Product Change Notification

December, 2008

Bourns® Model PDB18 Shaft Change

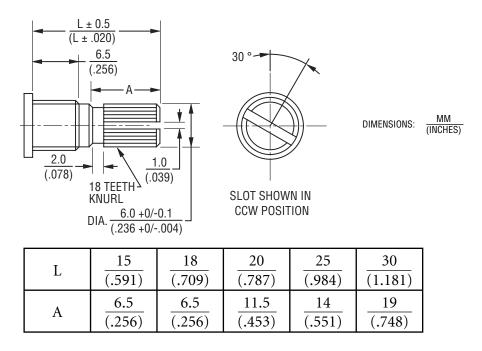
Sensors & Controls Product Group is announcing a product update to our Model PDB18 Potentiometer. We have phased in a minor change to the shaft configuration. Please reference the attached drawing below showing the design change to the shaft and associated shaft length options.

This change affects Model PDB181 and PDB182 with knurled shaft only. The shaft material will change from aluminum to zinc-die cast. In addition, the rear cover will be tin-plated rather than zinc-plated to allow customers to solder to the rear cover. Two new shaft lengths will be available: 15 mm and 18 mm. There are also a few minor dimension changes to the anti-rotation lug and terminals that do not affect fit. Please see the Model PDB18 data sheet for detailed dimensions.

The design change was phased in the week of September 15, 2008 with date codes beginning 0838. There are no changes to fit or function of this product. Distribution book prices will also remain unchanged.
